**ALERT SERVICE BULLETIN**  
**Bell Helicopter** **TEXTRON**

NO. 206-06-110

**MODEL AFFECTED:** 206A/B and TH-67 Series

**SUBJECT:** UPPER LEFT-HAND TAILBOOM ATTACHMENT  
HARDWARE, INSPECTION OF

**Figure 1: Tailboom Attachment**

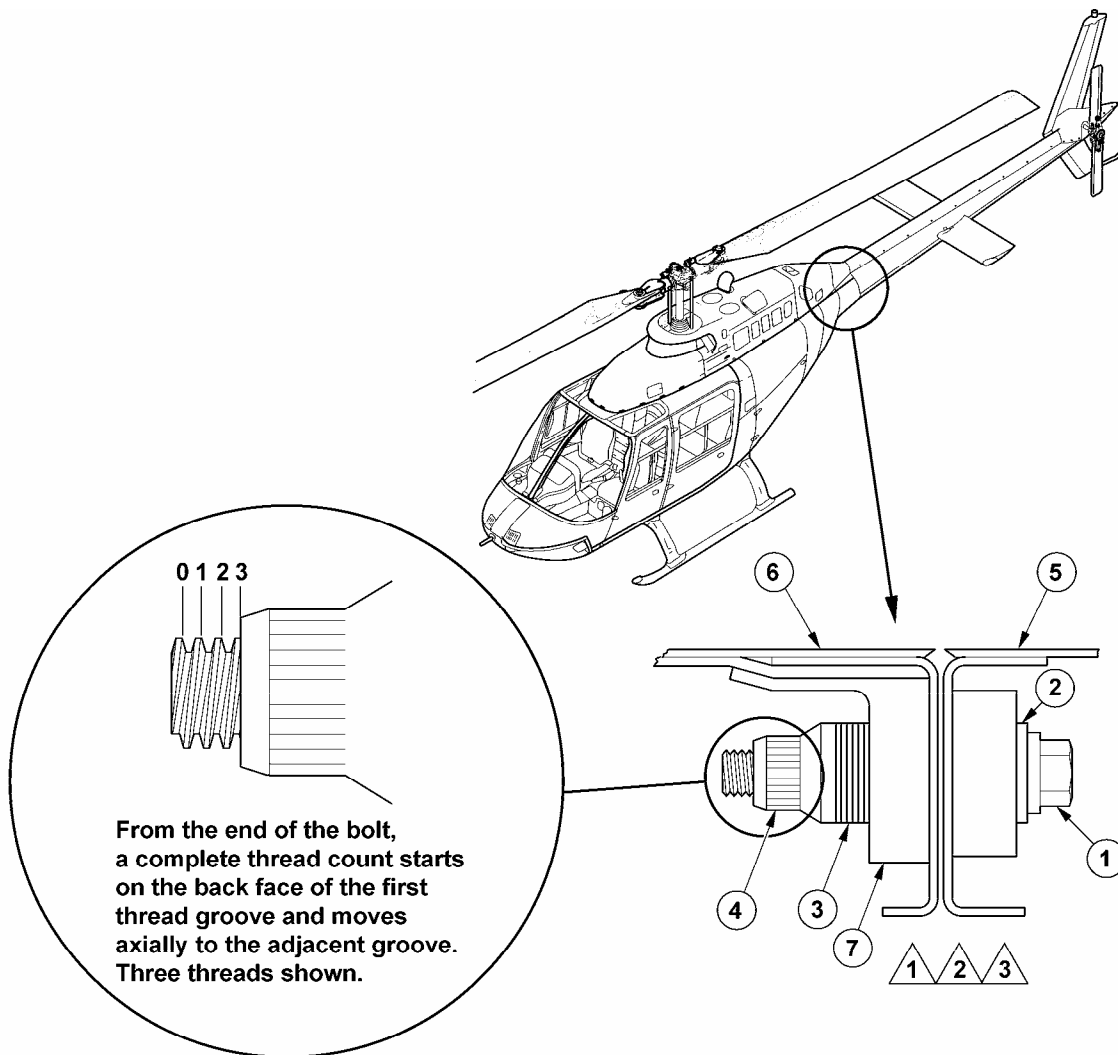
Bell Helicopter found that on some helicopters having the 407-030-750-103 CRES steel fitting installed at the upper left-hand location, the attachment bolt might not meet the installation requirement.

5. For helicopters affected by this bulletin that have a CRES fitting installed, perform thread count on the upper left hand attachment bolt (1) as per Figure 1.

6. If the correct amount of thread is exposed (between 1 and 3), do a torque check. Refer to the Maintenance Manual. If the torque is correct, make an entry in the helicopter records to indicate that this bulletin has been accomplished. If the torque is found below minimum and a replacement bolt (1) is not available at this time, adjust the washer (3) quantity as required per Figure 1. Refer to the Maintenance Manual and torque as required. Make an entry in the helicopter records to indicate that the PART I of this bulletin have been accomplished and that the PART II of this bulletin will require accomplishment.

7. If less than 1 thread is exposed, adjust the washer (3) quantity as required per Figure 1. Refer to the Maintenance Manual and torque as required. Make an entry in the helicopter records to indicate that this bulletin has been accomplished.

8. If more than 3 threads are exposed and a replacement bolt (1) is not available at this time, adjust the washer (3) quantity as required per Figure 1. Refer to the Maintenance Manual and torque as required. Make an entry in the helicopter records to indicate that the PART I of this bulletin have been accomplished and that the PART II of this bulletin will require accomplishment.

9. If more than 3 threads are exposed and a replacement bolt (1) is available, accomplish PART II of this bulletin.

1. Remove and discard the upper left hand tailboom attachment bolt (1, Figure 1). Install new bolt (1) and adjust the quantity of washer (3) as required to ensure correct installation as shown on Figure 1. If serviceable, the nut (4) does not require replacement. Refer to Maintenance Manual.
2. 100 hours after installation, do a torque check of the upper left hand tailboom attaching hardware (BHT-206A/B-SERIES-MM).
3. Make an entry in the helicopter records to indicate that this bulletin has been accomplished.

- 1 Bolt (1) and chamfered washer (2) are to be installed through tailboom (5) and Aft fuselage (6). Bolt head and chamfered washer are to be installed on the tailboom side. Steel washers (3) are to be installed next to fitting (7) to provide not less than one thread and not more than three threads exposed on threaded end of bolt (1).
- 2 If thread count is less than one, remove washers as required.
- 3 If thread count is more than three, remove and replace bolt, then readjust number of washers to meet requirement of note 1.
